IFSAR Quality Assessment Report

AK Chugach2 IFSAR C308 2016

NGTOC
2017-05-19
S Ruhl

Checkpoint Distribution Image

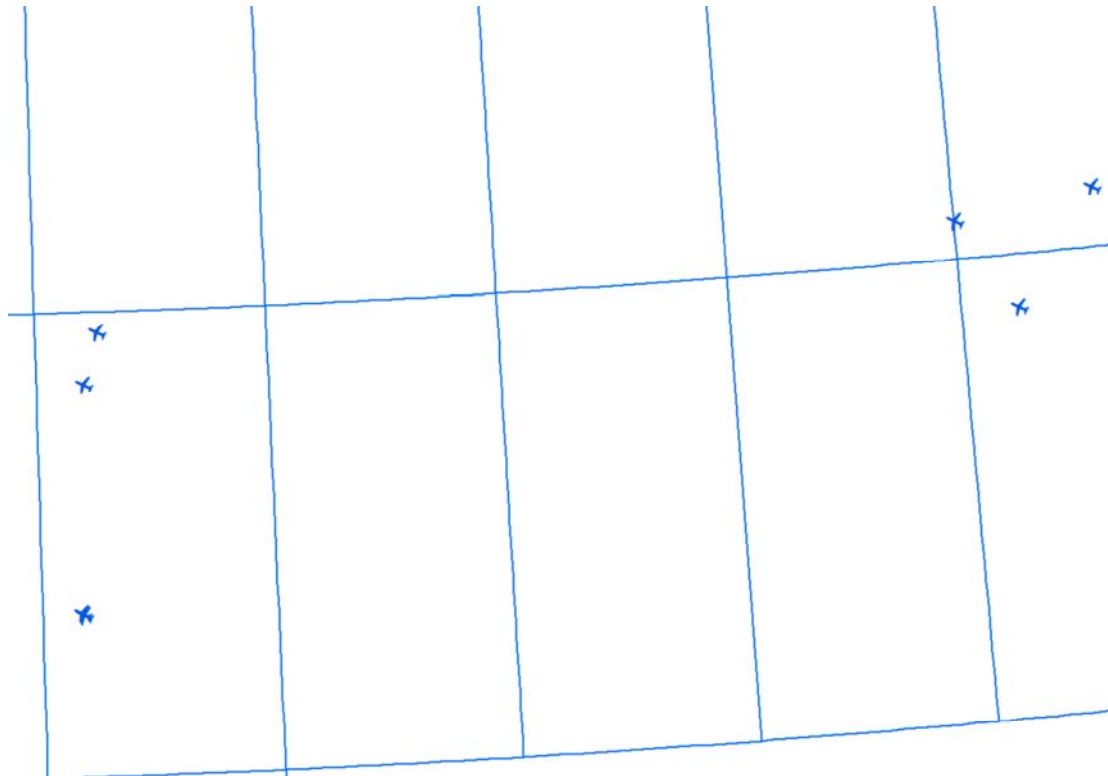
Checkpoints are well distributed?

Enough checkpoints for task order?

Enough checkpoints for NED?

Additional Reviewed
Vertical Accuracy
Information:

Based on this review, the USGS accepts the vertical accuracy.
